Access Compliance Report

Public Rights-of-Way

Intersection ID: 10027514	Main Street: GRANDIN_RD	Cross Street: N/A	Location: NW
ADA ID: 700A806DEE5C	Ramp Type: BlendTrans1	Initial Pass/Fail: Pass	Overall Compliance: No
Codes/Mitigation Info/Possible Solution		Field Measurements/Component Compliance	
Severity Score: 22.75

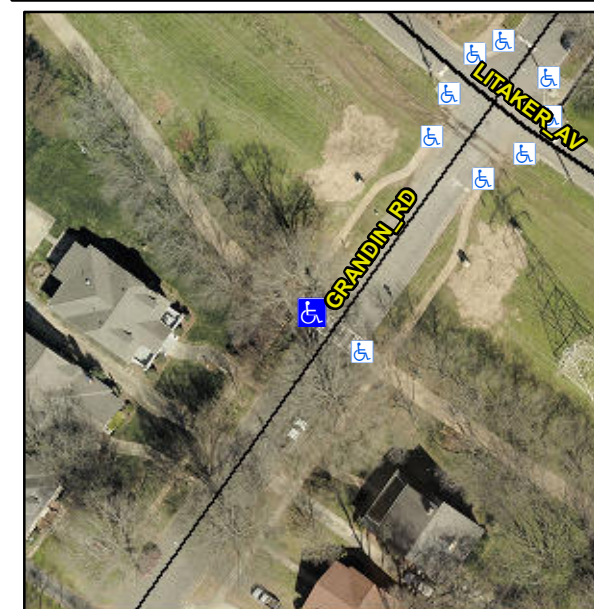
NO CURB

**R305, R302.7, R302.7.2, R304.5.4,
R304.5.3**

**Install Detectable Warning System.
Remove & Replace Gutter.**
